INDESIT company

Model type:
SAN400

Commercial code:
F061746

GDA5141020 Exploded views

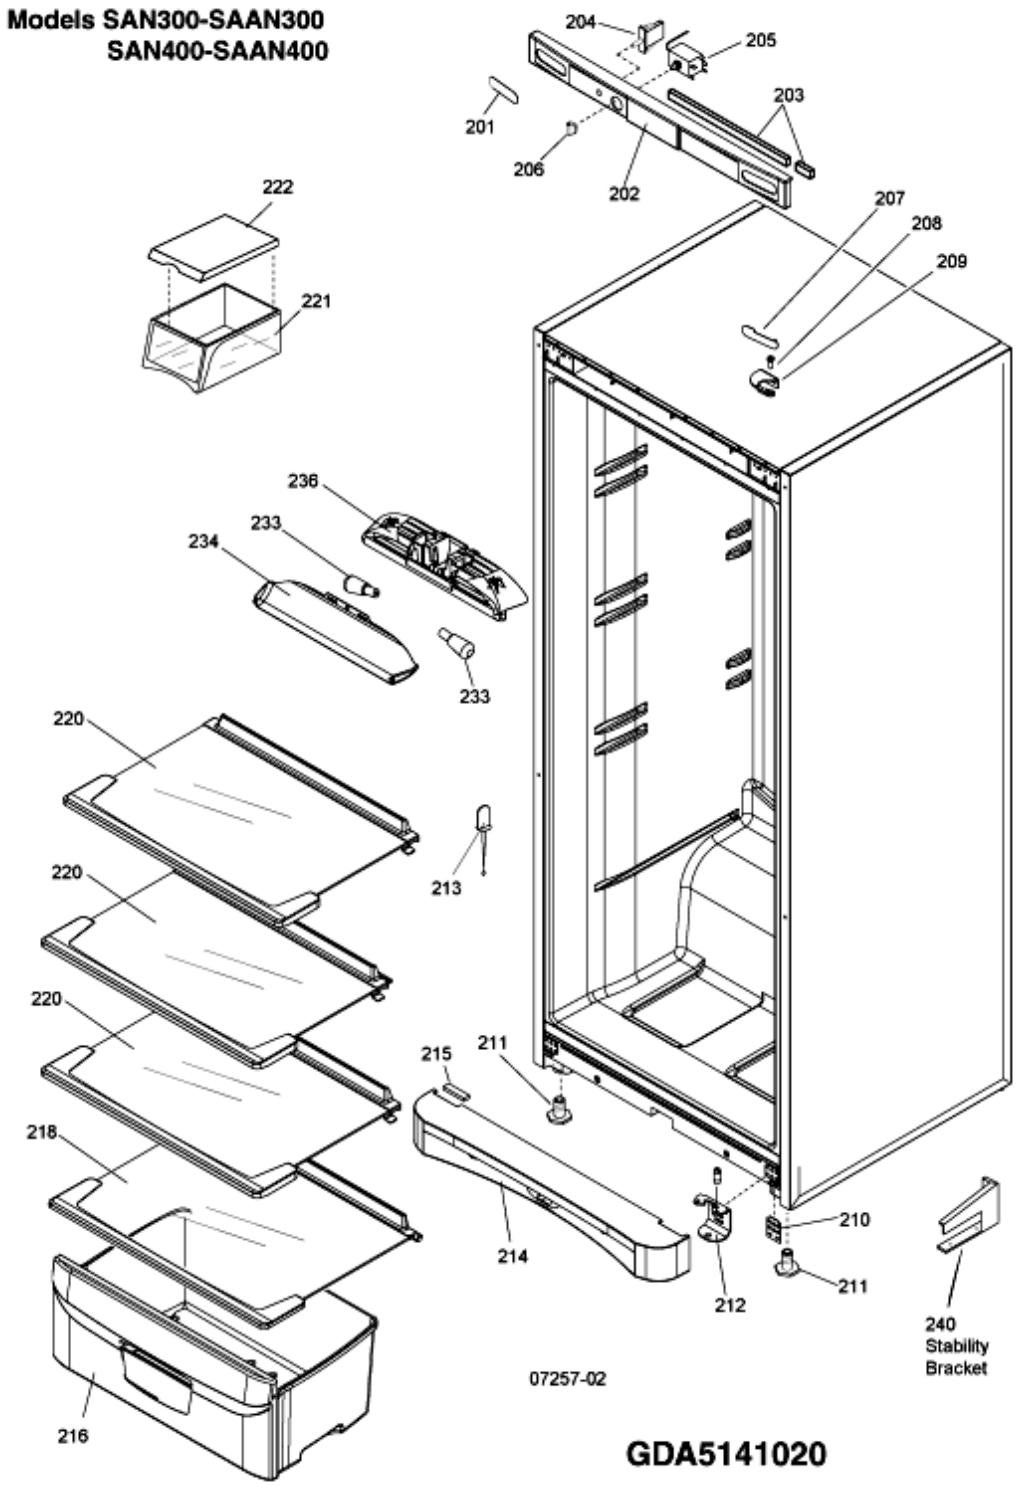
n2508c00: 3 TERMINAL THERMOSTAT WITH OFF POSITION

Thermostat 2 terminal to May 2008 - From June 2008 thermostat to be 3 terminal with OFF. When thermostat OFF interior light is also OFF.

GDA5141110 Exploded views

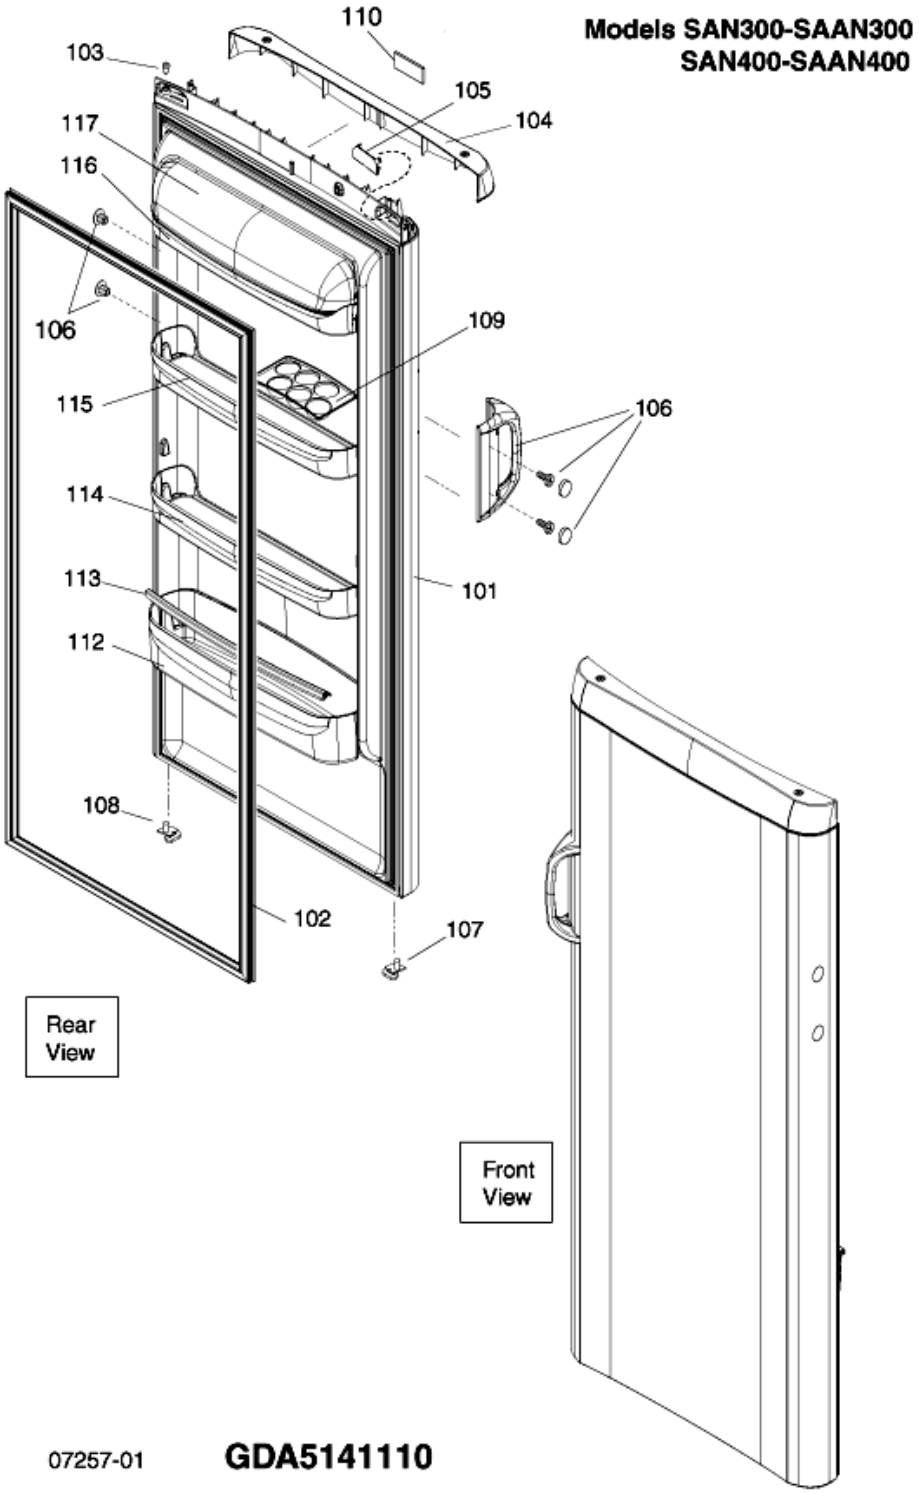
n2511b02: ELIMINATION COVER FOR UPPER DOOR SHELF-INTERNAL ACCESSORIES RESTYLING

Cover for upper door shelf has been eliminated. The upper door shelf has been standardized with the middle one. Subsequently has been standardized with transparent internal accessories instead of those in light blue colour once stock has depleted.

n3011e00: CHANGED EGG HOLDER FROM PW TO TRANSPARENT

CHANGED EGG HOLDER FROM PW TO TRANSPARENT

n3012a02: BOTTLE HOLDER HASE BEEN ELIMINATED
